UNITED STATES ENVIRONMENTAL PROTECTION AGENCY  
REGION IX – SOUTHERN CALIFORNIA FIELD OFFICE  
600 WILSHIRE BLVD, Suite 1460  
Los Angeles, CA 90017

Region 9 Enforcement Division  
75 Hawthorne Street  
San Francisco, CA 94105  
**INSPECTION REPORT**

Inspection Date:	02/24/2016		
Time:	Entry: 11:30 a.m.	Exit: 2:45 p.m.	
Media:	Water		
Regulatory Program:	CWA NPDES/Industrial Storm Water		
Company Name:	Modern Concepts, Inc.		
Facility or Site Name:	Modern Concepts, Inc.		
Facility/Site Physical Location:	3121 East Ana Street		
(city, state, zip code)	Compton, CA 90221		
Geographic Coordinates:	33°51'44.21"N, 118°12'23.16"W		
Weather	Sunny, no clouds		
Facility/Site Contact:	Richard Warpack	President	
	310-637-0013		
County:	Los Angeles County		
Facility/Site Identifier:	CA WDID#: 4 19I018552		
NPDES Number:	CAS000001		
SWRCB Order Number:	2014-0057-DWQ		
SIC Code:	3087 – Custom Compounding of Purchased Plastic Resins (SIC code identified on facility's SWPPP dated 06/29/2015)		
<b>Facility/Site Personnel Participating in Inspection:</b>			
Richard Warpack	President		
Aris Barrios	Vice President		
<b>Inspector:</b>			
Daniel Haskell (Lead)	Water Section II Southern California Field

*Image A: Google Earth image of Facility  
3121 East Ana Street, Compton, CA 90221*

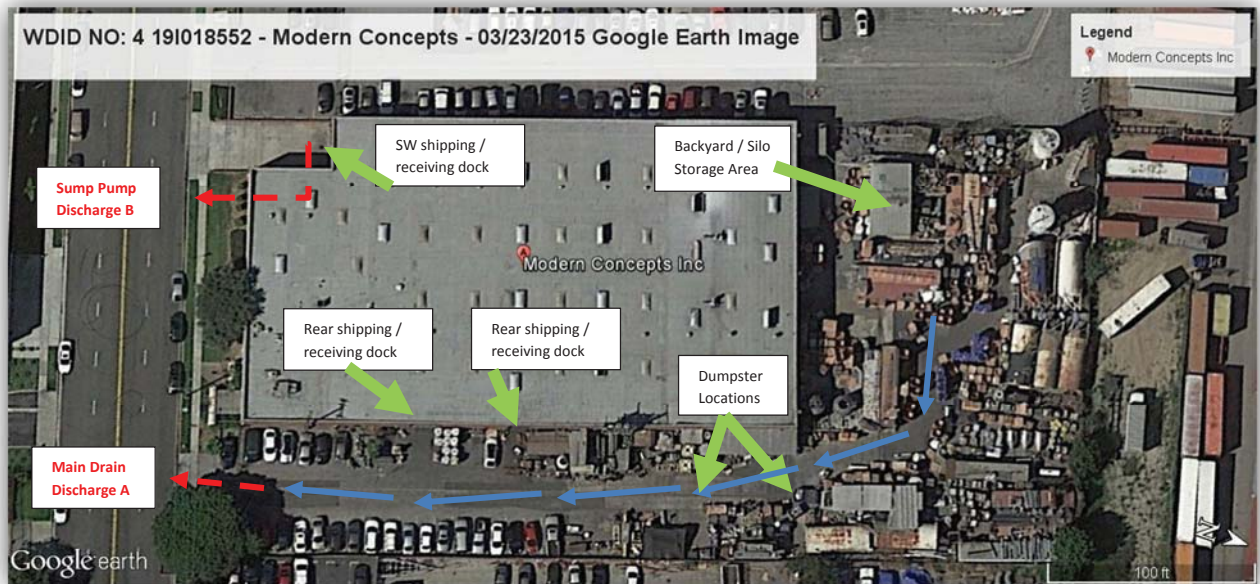
According to the SWPPP site map provided during the inspection, the Facility has two discharge points located along the southern facility border facing East Ana St. The discharge point located at the entrance of the Facility parking lot at the south east corner is the primary discharge point most representative of facility conditions. The site map labels this discharge point as Main Drain Discharge A. Main Drain Discharge A receives storm water discharge from the silo storage area, backyard, parking lot, and shipping dock discharges which includes the southern portion of the roof via a 3 x 6 inch down spout. According to the SWPPP site map, the storm water flow path begins at the silo

The discharge point located at the southwest corner of the Facility is labeled Sump Pump Discharge B according to the site map. Sump Pump Discharge B receives storm water discharge from a separate smaller discharge area of the facility at the southwest shipping dock. It has a sump pump, which is contained until the pump is automatically activated by a float level and is discharged to East Ana St. The adjacent storm drain maps were also taken off the Los Angeles Department of Public Works website (Image B). The closest storm drains to these discharge points are Compton Creek to the west (Image C) and Susana Drain to the east (Image D) both of which, are on East Ana St.
